SUBJECT: Downtown Phase II Development -
Planned Development – Preliminary Plan

PC Case No: 3487

Date: July 19, 2018
To: Greg Hannan, Community Development Director
From: Thomas J. Sheridan, P.E., P.S., Asst. City Manager – Professional Services
Re: **Downtown Phase 2 Development Traffic Engineering Review**

Subject: Hudson Phase 2 Project
Site Plan Review

CITY OF HUDSON
FIRST & MAIN DEVELOPMENT
PHASE II

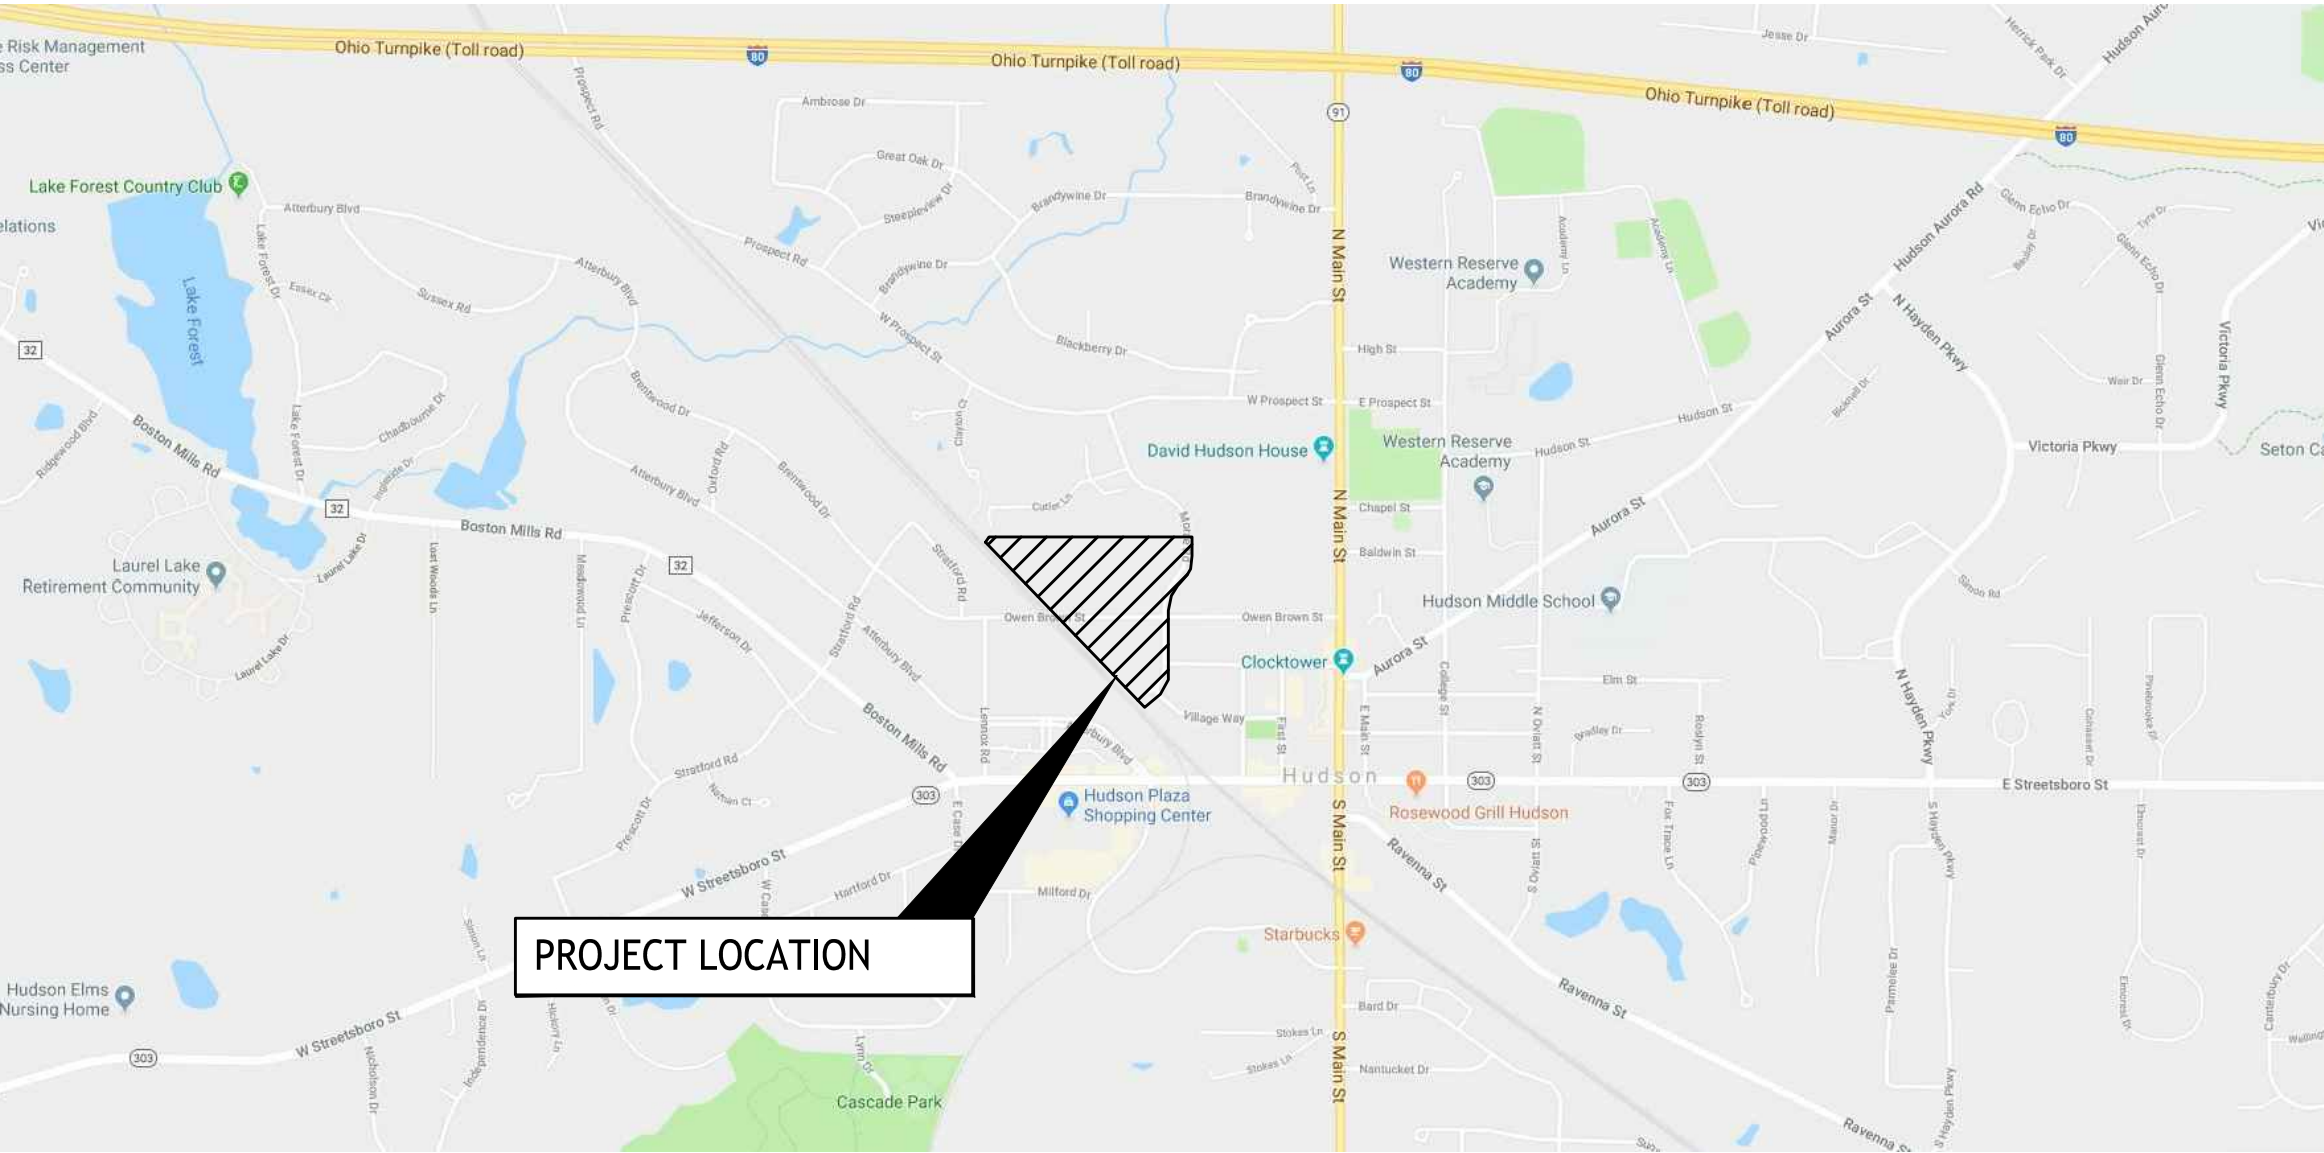
- The areas along the Morse Road intersection approaches and across their included corners should be clear of obstructions that might block a driver's view of potentially conflicting vehicles. These unobstructed areas are known as sight triangles. The provision of sight triangles also allows the driver on the major road to see any vehicles stopped on the minor road approach and to be prepared to slow or stop, if necessary.

- Proper sight distance should be provided at all intersections along Morse Road. At a minimum the necessary stopping sight distance of 200 feet for a design speed of 30 miles should be provided for northbound and southbound vehicles on Morse Road approaching the intersections. The setback and/or height of all buildings, signs, and landscaping should be sufficient, so vehicles have an unobstructed view approaching the intersection.

- It is also practical to provide adequate intersection sight distance for vehicles turning from the side streets onto Morse Road. Intersection sight distance allows for turning vehicles to adequately see oncoming traffic, make a decision, and execute their turn maneuver. 335 feet of available intersection sight distance is recommended for left turning vehicles and a design speed of 30 miles. 290 feet of intersection sight distance is recommended for right turning vehicles and a design speed of 30 miles per hour. The setback and/or height of all buildings, signs, and landscaping should be sufficient so vehicles on the minor street have an unobstructed view along the north and south Morse Road approaches for a minimum of 335 feet.

- The use of traffic signals and smart signal technology at the Owen Brown underpass can be used to control the right-of-way through the underpass. A phase in the signal operation can be used to allow for a pedestrian only phase where vehicles are held on each side of the underpass while pedestrians use the underpass.

- There is an existing access along the north side of Owen Brown to the east of the underpass and a proposed access directly across from it. These driveways should be placed outside the traffic control for the underpass so they can see the control and operation of the underpass.

- The intersection of Morse Road and Owen Brown Street is recommended to have stop sign control on the Owen Brown Street approaches.
- The intersection of Morse Road and Clinton Street is recommended to have stop sign control on the Clinton Street approach.
- The intersection of Morse Road and Village Way is recommended to have stop sign control on all three approaches due to the intersection configuration impacting the ability of vehicles to see each other. Roundabout control at this intersection would be a viable alternative.
- The intersection of Morse Road and Village Way would need to be re-aligned to create a more traditional T-intersection to allow continuous flow along Village Way with minor street stop sign control on Morse Road.

- The use of the median along Village Way is only necessary at Owen Brown Street to prevent the east-west through movement.
- The use of bollards and pavement markings at Owen Brown Street and Village Way can be used as a temporary installation to determine the impact of restricting movements at this intersection before constructing a more permanent raised median.

- Turning radius analyses should be performed each end of the medians on Village Way and Owen Brown. Appropriate signage that prohibits u-turns should be placed at all locations where the radius and roadway width is not sufficient to allow a u-turn maneuver. All signs prohibiting u-turns should be in conformance with the guidelines and recommendations found in the **OMUTCD**.

- The use of roundabouts at the intersections of Village Way with Road B or Road A should be considered for their ability to allow a u-turn type maneuver at the end of the medians.

- Westbound left turns through the median at Owen Brown Street and Village Way could be permitted through the use of a channelized turn lane that would direct the left turn movement and still prohibit the through movement across the intersection.

- The east end of the Owen Brown median at Village Way should be constructed to channelize the eastbound right turn movement to reduce the chance of a vehicle turning left and proceeding in the wrong direction against southbound traffic.

- Consideration should be given to restricting or closing the proposed access along the south side of Owen Brown between the underpass and Block B so the parking area does not become a cut-through option with the westbound left turn restriction at the intersection of Owen Brown Street and Village Way.
- Wayfinding signage is recommended throughout the development that directs motorists to places of interest within the downtown area as well as to roadways within the study area for ingress and egress to the development site.
